DSO Entity views on Aggregation of PGMs

Under NC RfG 2.0 revision

ESC - Discussion Document

As a follow-up on the ESC GC Meeting held on 12 March 2024

Example 1

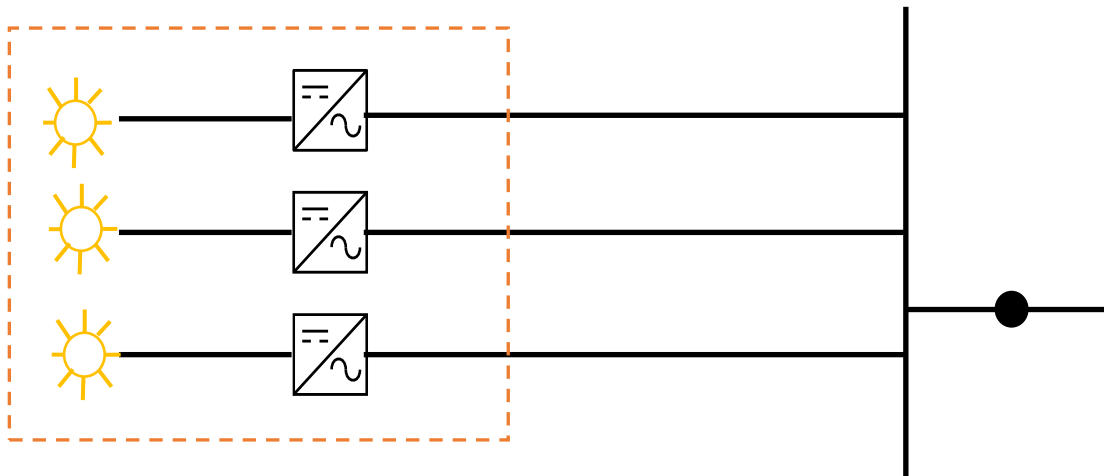
- All generating units are single technology, so the future interpretation remains a single PPM

Example 4

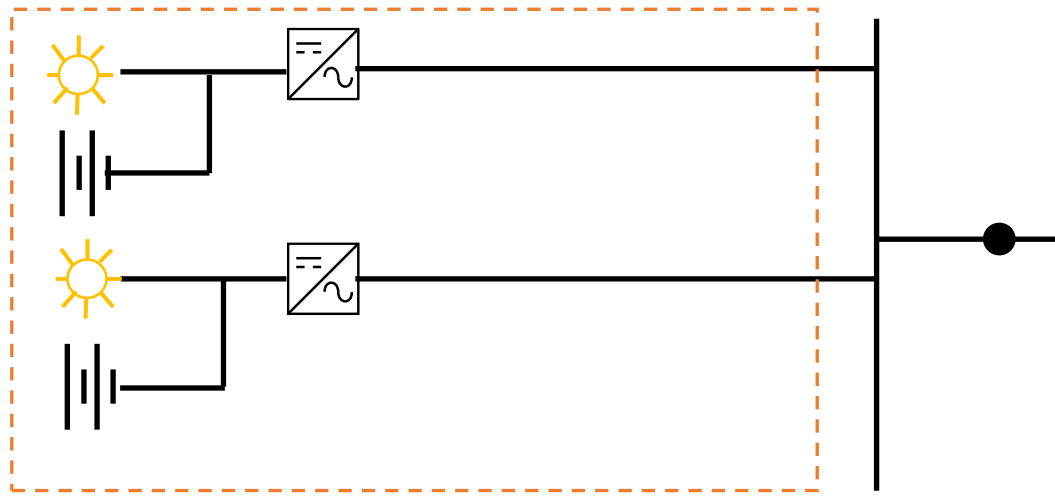
- PV and battery are comparable size; the battery does not exist to supplement PV for compliance purposes (ie capable of independent modulation)
- So the battery is not there to complement the other generating unit's compliance.
- The inverter rating decides the type of the PPM (not the solar PV array or battery capacity)
- We think the battery and solar have to be treated as an ESM because otherwise the ESM provisions of the NC RfG 2.0 (Art 13.3(h), 13.7, 13.11) would not apply

Example 6

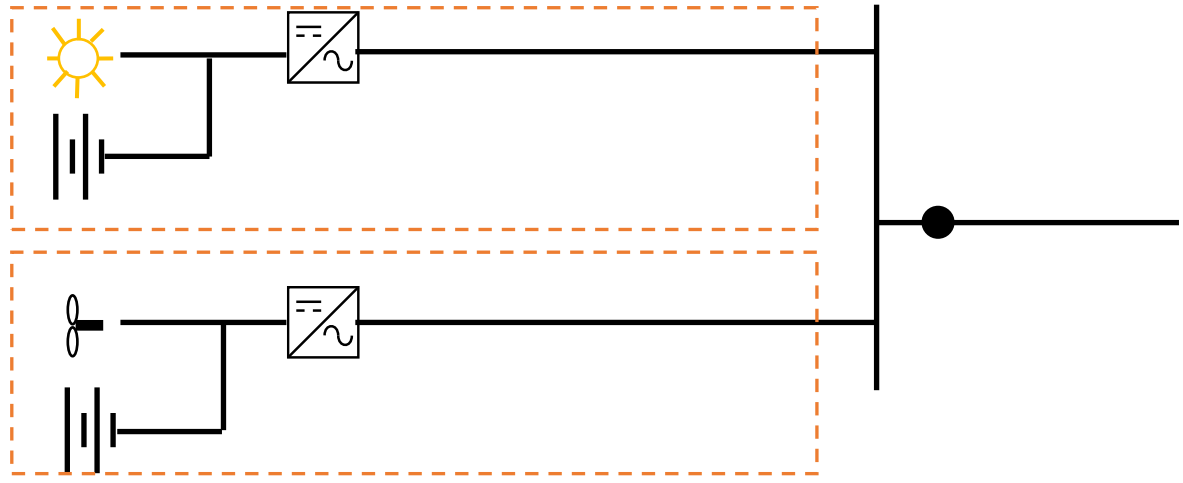
- PV/wind and battery are comparable size; the battery does not exist to supplement the PPU (PV/Wind) for compliance purposes
- What criteria differentiate one technology from another? Wind versus solar?
- Are these ESMs or PPMs? ESMs – see note on slide 8 - example 4
